PROJECT: Webster University - Interdisciplinary Science Building
ENGINEER: Cannon Design
DESCRIPTION: Linear Slot Supply, 1" Slot
SDS100/II/48.000/1/14/II/ZZ/II/B12

Shop Drawing Submittal Review

Project Name: Webster University-**ISB**

Copies	No.	Description
1 PDF	238800M08	(Submittal No.'s:) (R&B-CxSRC)
		(Cannon #238800-11) - (Paric #15051-0370) - (WES #607)
		➤ Air Distribution – Price Air Devices

SDS100 1" Slot Linear Supply

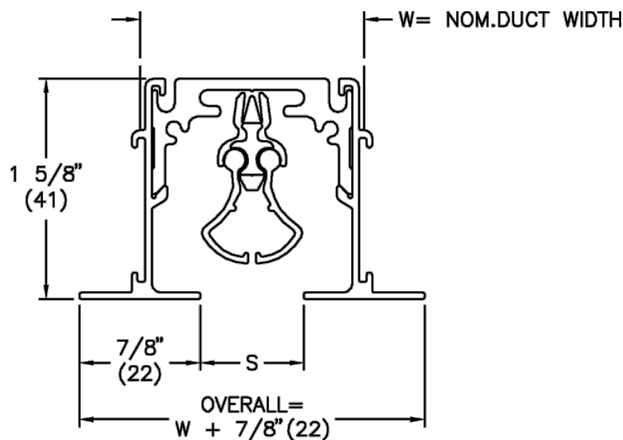
- 1. Confirm device quantities.**
- 2. Verify ceiling construction with frame types.**
